DEVELOPMENT REVIEW BOARD--SPEED MEMO

DRB CASE NO/PROJECT NO: 1003675

DEVELOPMENT REVIEW BOARD – SPEED MEMO

RE: Lot 1, Torres Addition; Tract C8, Town of Atrisco Grant, Airport Unit; & Lots 1, 4, Block C, Lavaland Addition

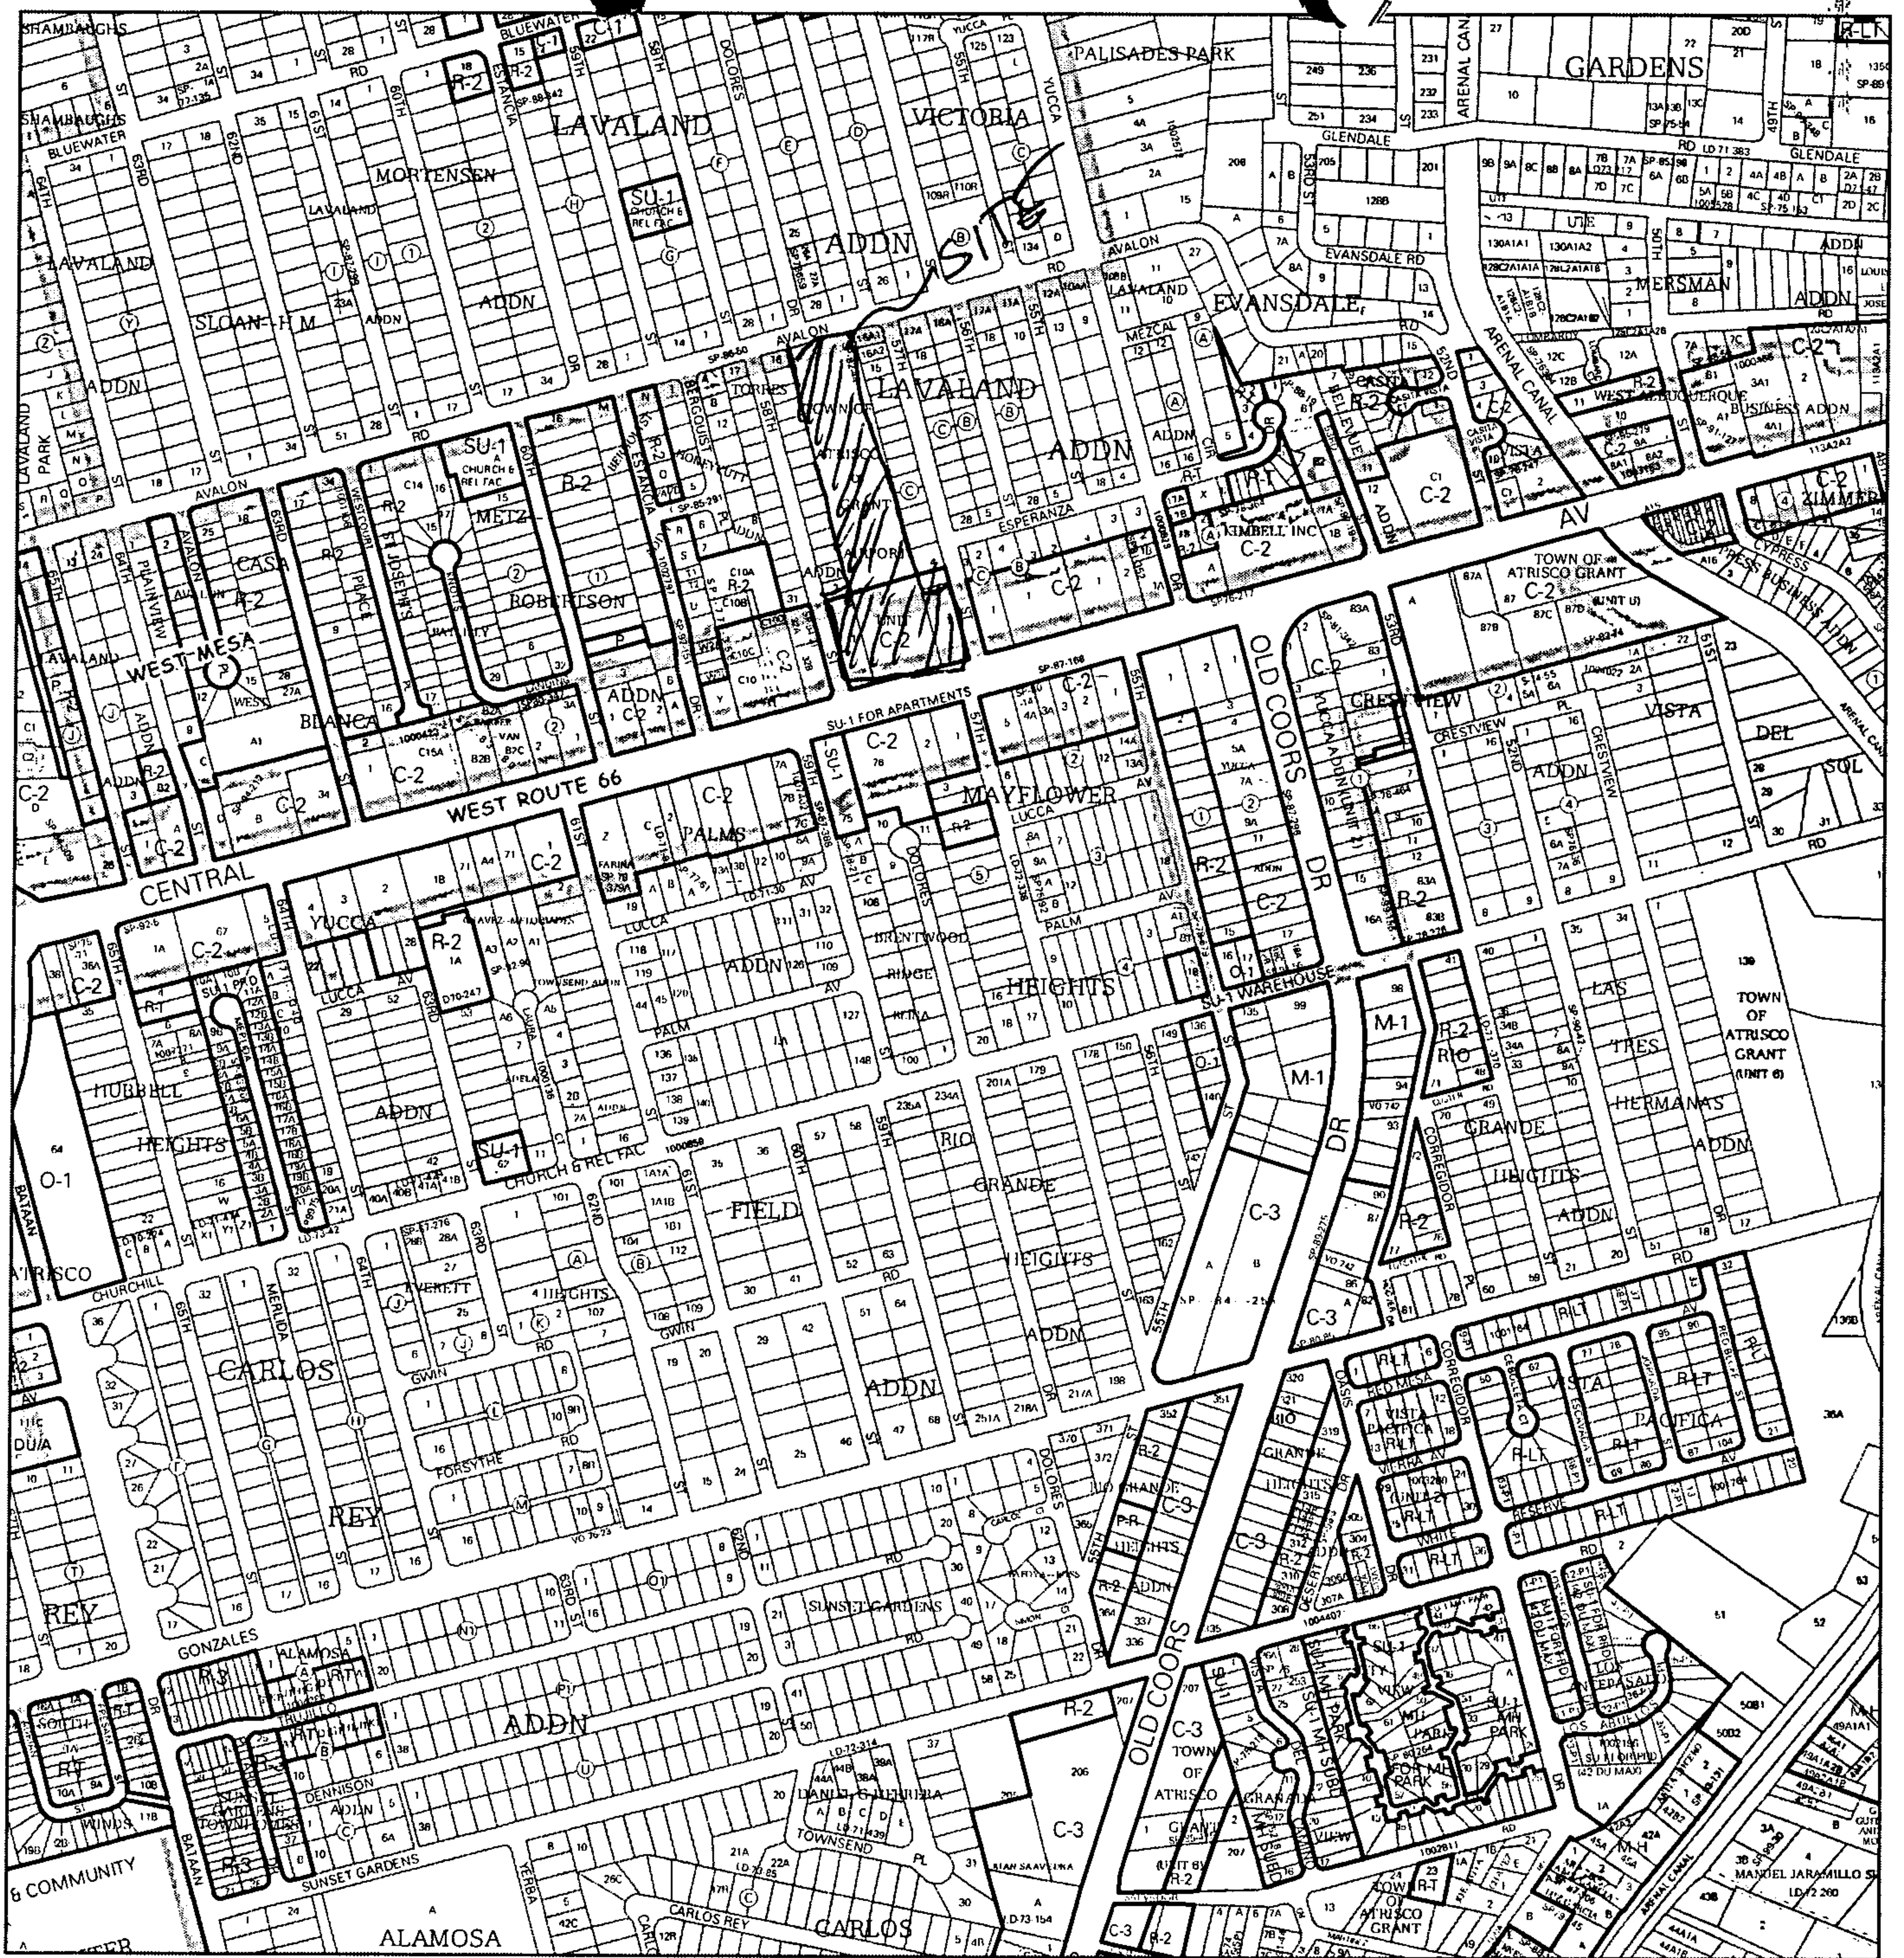
Provide an exhibit showing the location of sidewalk and defining the distance from face of curb to the property line. Right of way dedication may be required.

Geometric information (aisle widths, parking stall dimensions, all radii, slopes on ramps, etc.) must be provided prior to a complete review.

Please note that all proposed right-of-way, street geometry and roadway infrastructure must comply with the City of Albuquerque Development Process Manual and Standard Specifications. What are the lot designations and will they comply with the roadway widths?

Are the proposed streets private or public?

Please call out the distance between the existing and proposed Esperanza Drive. The proposed alignment for the extension of Esperanza Drive does not appear to meet the criteria outlined above.

The proposed residential lots do not meet the minimum requirements of the existing R-1 zoning district. Additionally, attached dwellings are not allowed, and there are incremental setback requirements for lots on a street which is aligned within 30° of north per §14-16-2-6 (E)(4)(c) of the Zoning Code. Based on 'Typical Lot Layout' a zone change to R-T would be required; however, increasing lot area to 3,200 sq ft and having maximum 3 dwellings attached would only require R-LT. Zone change requests must be justified per Resolution 270-1980 and approved by the Environmental Planning Commission. Required parking cannot count spaces aligned in tandem – a revised parking plan is needed.

Residential use is strictly regulated in the C-2 zone; a zone change would also be needed for proposed Lots 35 and 36. Further, the C-2 portion of this site is within the West Route 66 Sector Development Plan area and would be subject to those regulations.

Extension of Esperanza Drive appears unneeded given proposed Street "C." Regardless, a Subdivision Design Variance would need to be requested for block length greater than 600 feet.

Re: Tract C-8 Atrisco Grant

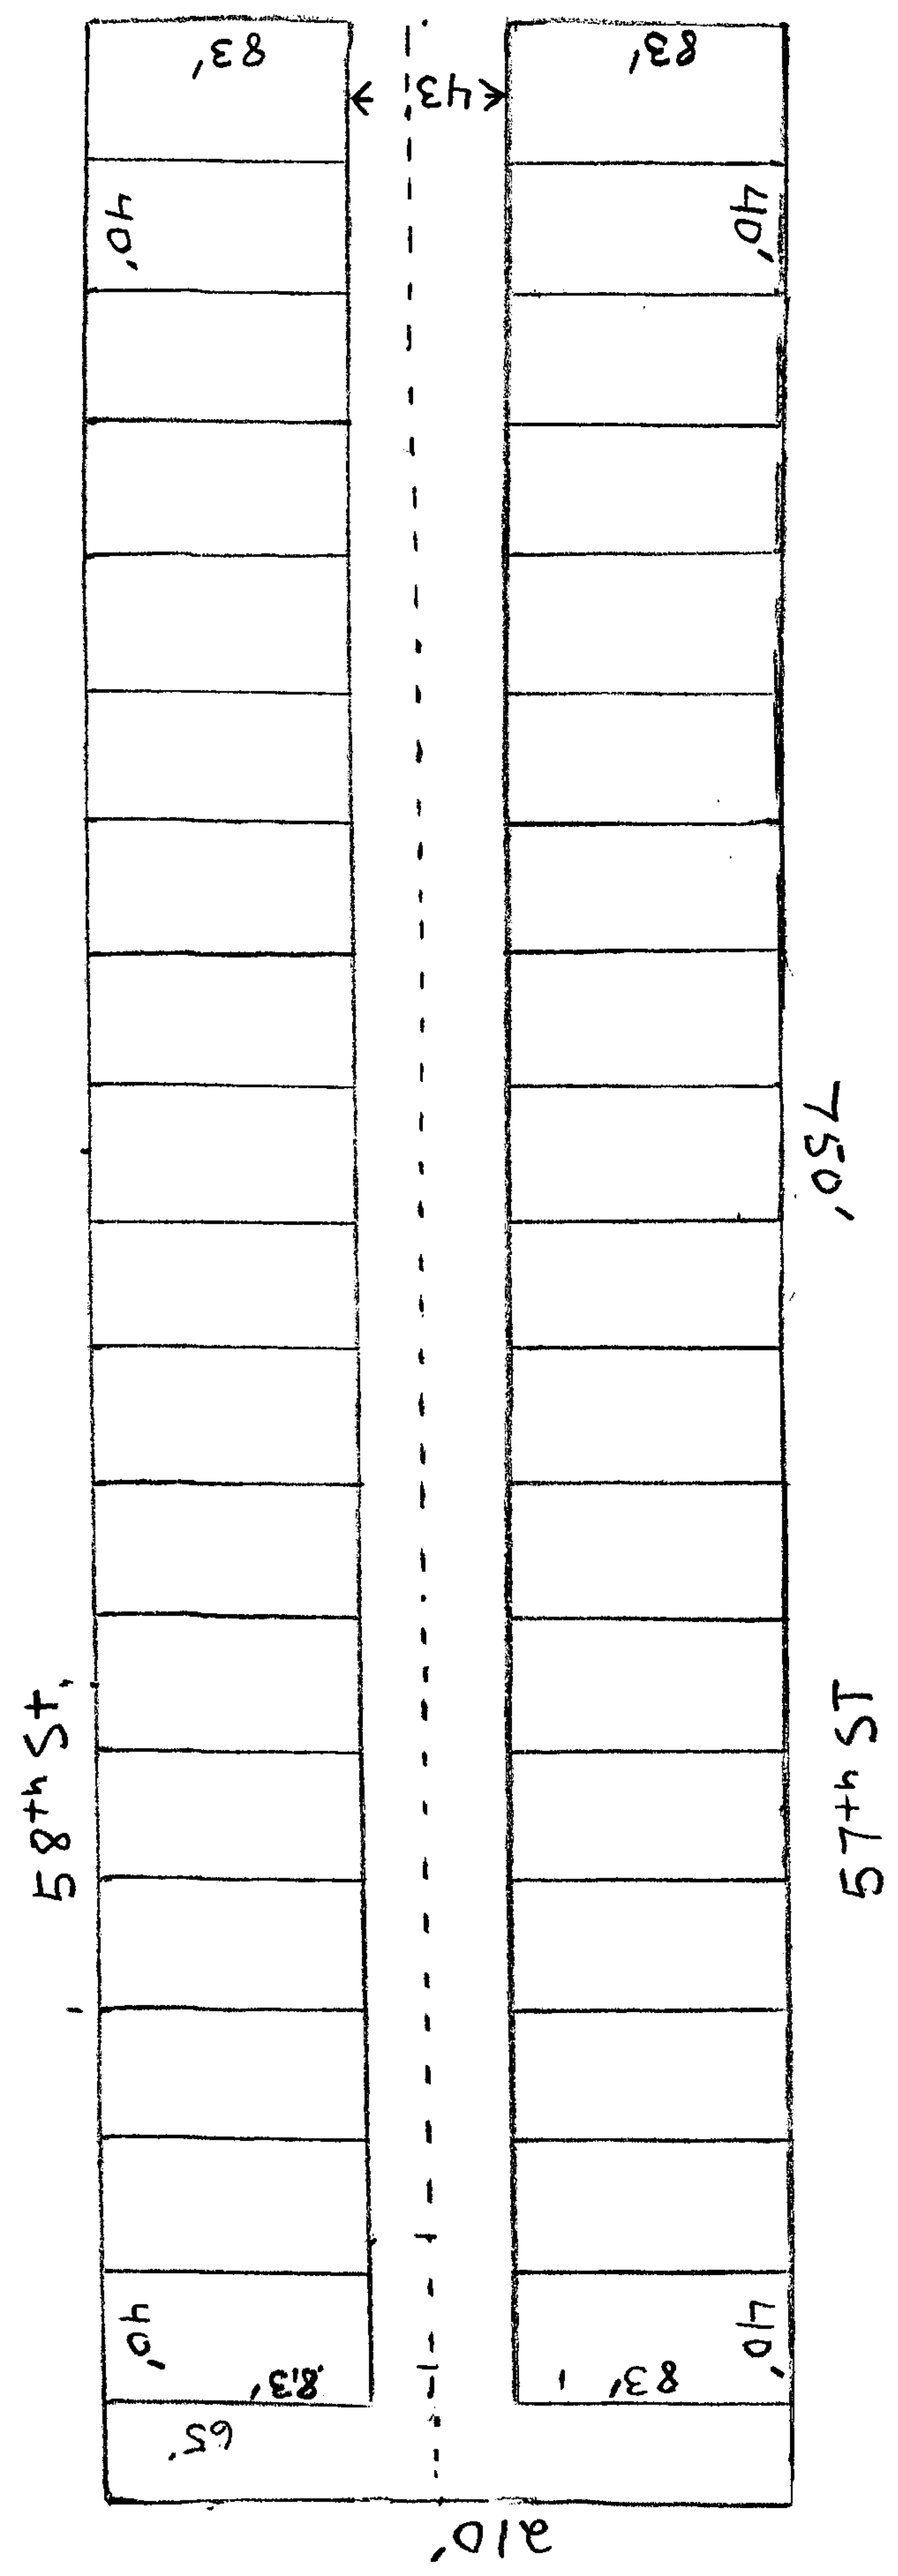
The County Assessor's records do not show Homes of New Mexico as the property owner for this lot. We will need proof of ownership at the time of replat application.

The south lot line for this property actually extends to Central Avenue. A zoning line exists which divided this lot into C-2 for about a quarter of the southern portion of this lot. The replat will have to divide the property to separate the C-2 zoning from the R-1.

The sketch submitted shows new lots smaller in square footage & minimum lot width than what is allowed in R-1 zoning. The minimum lot width in this area is 50 feet and the minimum lot size is 5,000 square feet.

There are also building setbacks in R-1 zoning which must be followed in developing the property.

In addition, any perimeter walls adjacent to streets must have an approved perimeter wall design prior to preliminary plat approval.

Going to re-zone
